February 4, 2019

Recommendation

RNP AR OCS TRANSITION HARMONIZATION

Figure 1.

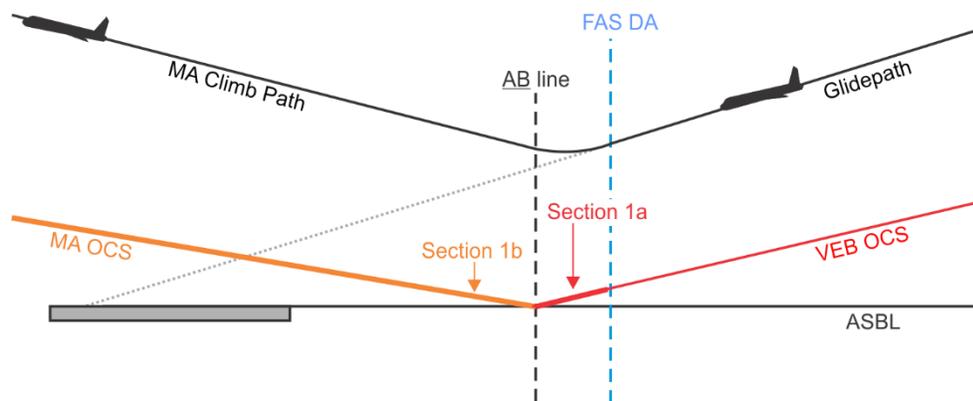
Figure 1 is an example where the RNP AR procedure design criteria limits construction where Section 1a sloping surface intersects the ground. The intent of the downward slope of Section 1a of the OCS beyond DA is to protect for a 50' height loss by the aircraft when the flight crew initiates a go-around at DA to begin the missed approach.

Figure 2.

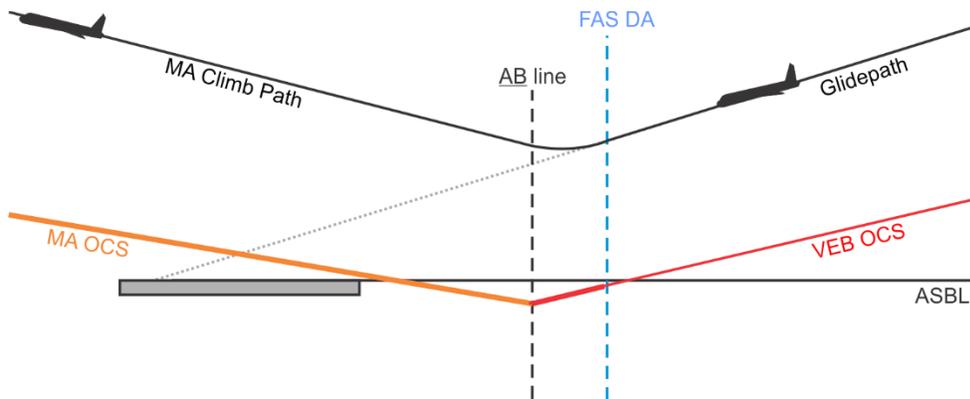
Figure 2 shows the existing surfaces with a HAT of 250'. The RNP AR vertical error budget's (VEB) OCS extends below the ASBL. Since the criteria prohibits a penetration of the OCS, the procedure designer using existing criteria must raise the DA so that the MAS OCS does not have a penetration.

Figure 3.

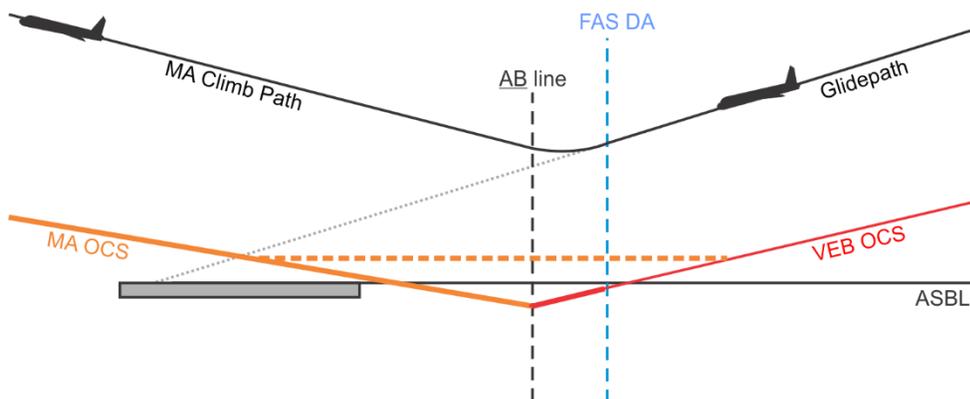
Figure 3 illustrates the PARC Nav WG proposal to amend the vertical OCS and protect the aircraft's height loss through use of our current OCS procedure design criteria for an RNP APCH (*i.e.* an approach titled "RNAV (GPS)") and the LNAV/VNAV line of minima. The dashed orange line connecting the VEB OCS to the MA OCS is an application of the required obstacle clearance (ROC) from 8260.58A Table 3-3-2, and this criterion is in harmony with the LNAV/VNAV methodology and the RNP AR procedure design criteria in ICAO Doc 9905.

Reno RNP RWY 16R

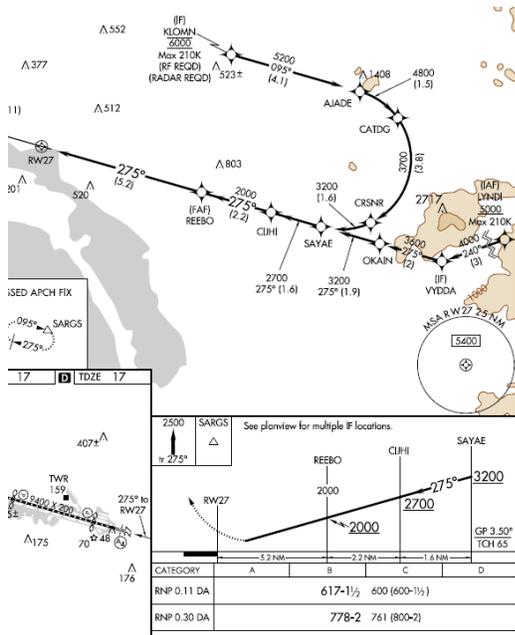
Reno RNP RWY 16R has a MAS 1b controlling obstacle of a 4507' terrain point within today's level OCS segment. This terrain would not push the HAT above 250' if the procedure designer applies the height loss protection of this proposal.
